INSPECTORS REPORT ON A LICENCE APPLICATION

| RE: | APPLICATION FOR A WASTE LICENCE (REVIEW) FROM CORK COUNTY COUNCIL, LICENCE REGISTER 68-2, YOUGHAL LANDFILL. | |

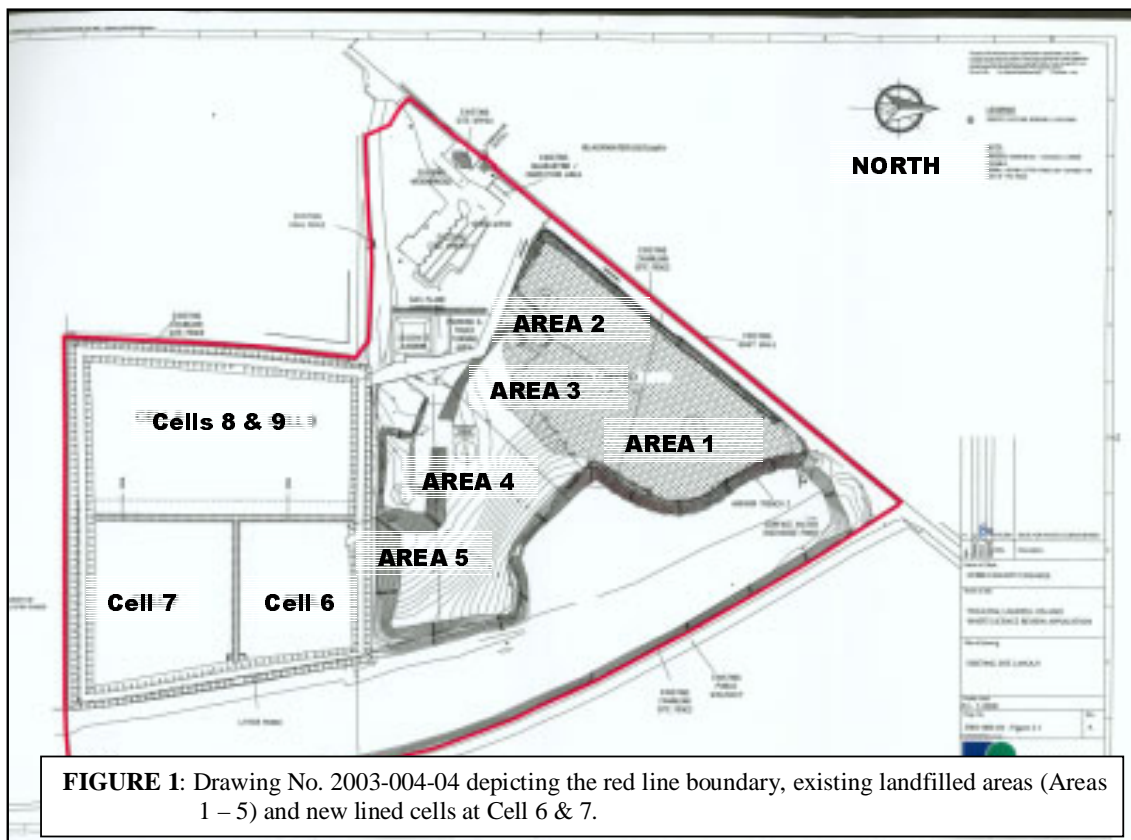
The landfill can be split into three parts (*Figure 1* below outlines the landfill areas):

- Part 1: Areas 1 – 5, original waste body, unlined, existing domed area; Areas 1 – 3 capped, capping to be completed at areas 4 & 5;
- Part 2: New lined cells 6 & 7 (area 17,000m²), filling to start late 2004;
- Part 3: proposed site for next two lined cells (area 17,500m²);
